Hume Coal & Berrima Rail Project

Stakeholder Briefing to the Independent Planning Commission – Second Referral

29 June 2021

Visual impact (R15)

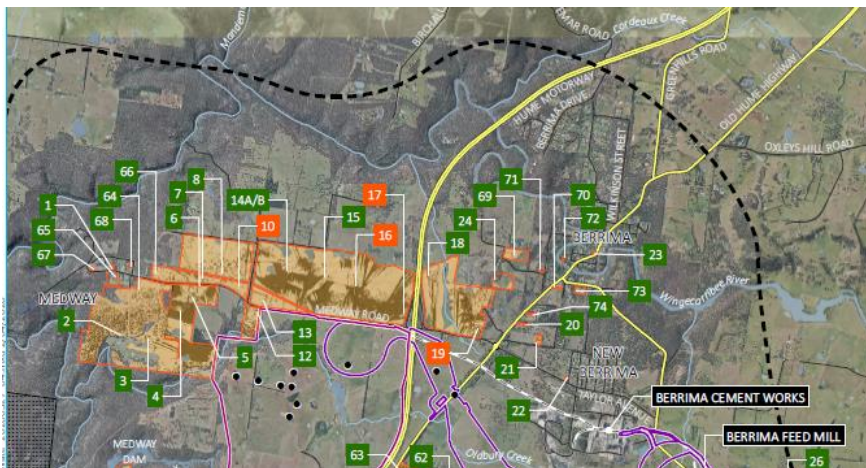
Commission - Further visual impact assessment should be completed for assessment

- Revised visual impact assessment completed to industry standards included within the UK document *Guidelines for Landscape and Visual Impact Assessment (GLVIA) Third Edition* (Landscape Institute 2013)
- 4 landholders will potentially have a view of the SIA (without screening). Screening committed to, which will further reduce potential for views.
